UNITED STATES PATENT AND TRADEMARK OFFICE

10/076,275

Office Action Summary

DETAILED ACTION

FIG. 3.

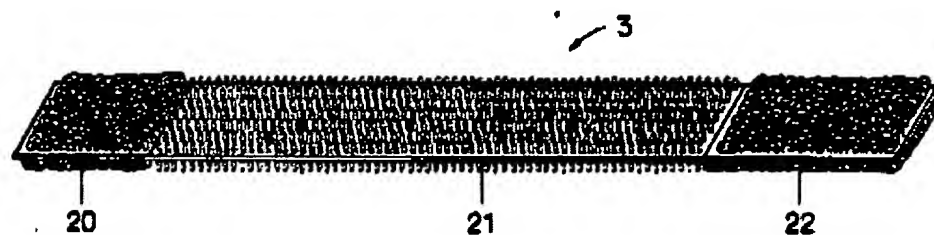
Hahn (figures 1-4d) teaches a folding tie 3 comprising three segments, two end segments 20, 22 with loop material on the opposite major faces and a central segment 21 with hook material on the opposite major faces connecting the two end segments 20, 22. Folding tie 3 is reproduced below from figure 3:

The description of the use of the tie is consistent with that shown in figures 4a and 4b wherein the cord 24 is placed at the intersection of segments 20 and 21 with the segment 20 folded over the cord so that the top surfaces of the two segments engage in the same manner as required for tie 1.

The difference is that while Hahn provides structure for folding and joining the three segments 20, 21, 22, the segments having the hook and loop material on opposite major faces are immediately adjacent each other so that the folding and joining structure is not clearly located between the segments.

FIG. 9

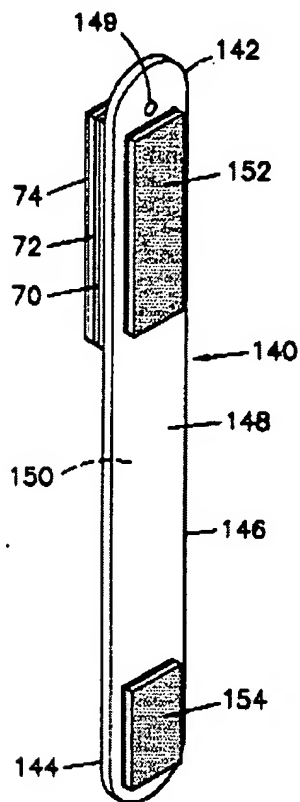
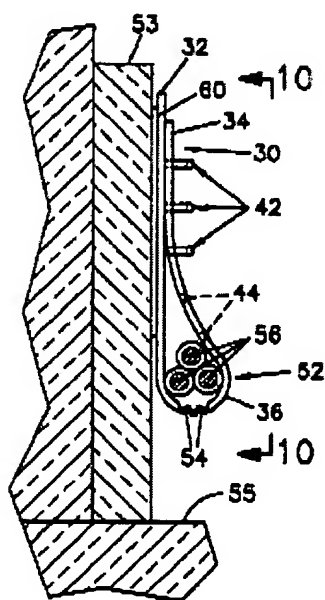
However, Polad (figures 6, 8, 9) teaches spacing the interlocking materials 152, 154 apart and that hinge grooves can be placed in the centered portion so as to form a narrowed hinge fold axis, an example of which is identified by reference numeral 54 in figure 9. Figures 6, 8, 9 and the descriptive material of figure 6 found in column 5, lines 7-37 are reproduced below:

Polad indicates that it is desirable to provide a fold axis defined by hinge grooves between spaced interlocking segments as allowing easier bending at a preferred area between the spaced interlocking segments.

As making the tie of Hahn easier to manipulate by bending at the juncture of the segments where a cable is located is desirable, it would have been obvious to modify the tie of Hahn so that the interlocking segments are spaced by the folding and joining structure in view of Polad suggesting such structure as being desirable to permit easier bending at a preferred area of cable placement.
